PROPOSED TECHNICAL SPECIFICATION CHANGES

SURVEILLANCE, AUDIT FREQUENCY AND ADMINISTRATIVE CHANGES

POWER AUTHORITY OF THE STATE OF NEW YORK
JAMES A. FITZPATRICK NUCLEAR POWER PLANT
DOCKET NO. 50-333

FIGURE 6.2-1

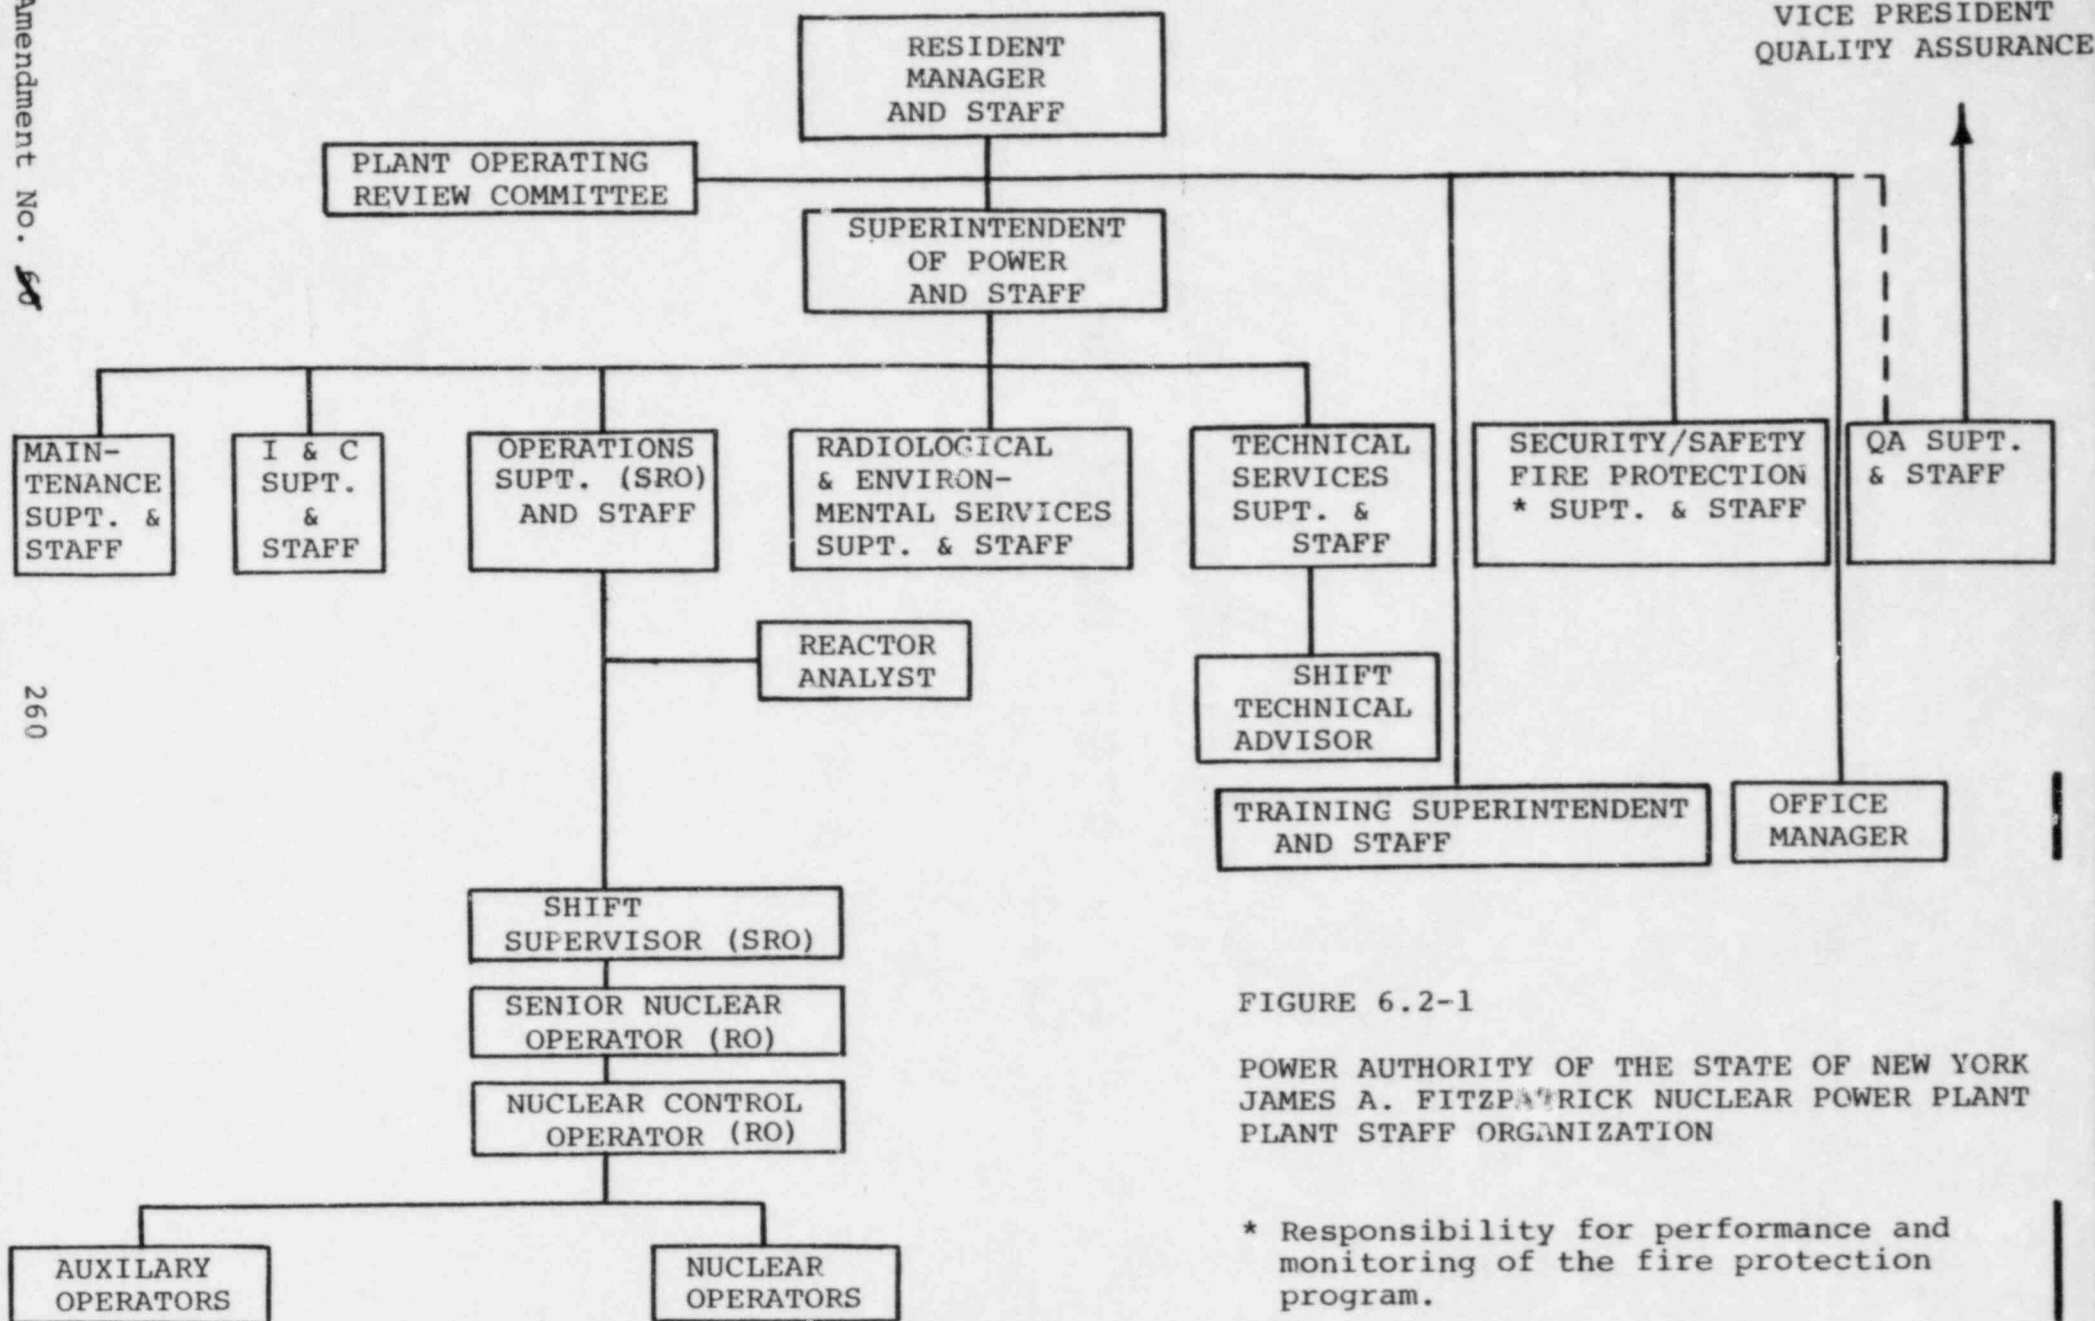
Figure 6.2-1, "Plant Staff Organization" on page 260 is updated to show that the Security and Safety Superintendent has responsibility for performance and monitoring of the fire protection program, in accordance with our previous commitment.

One of the two changes to Figure 6.2-1 incorporates an existing NRC commitment into the FitzPatrick Technical Specifications regarding the Security and Safety Superintendent's job function. The second changes the "Training Coordinator" block to read "Training Superintendent and Staff" to agree with current Authority organization and titles.

* Responsibility for performance and monitoring of the fire protection program.
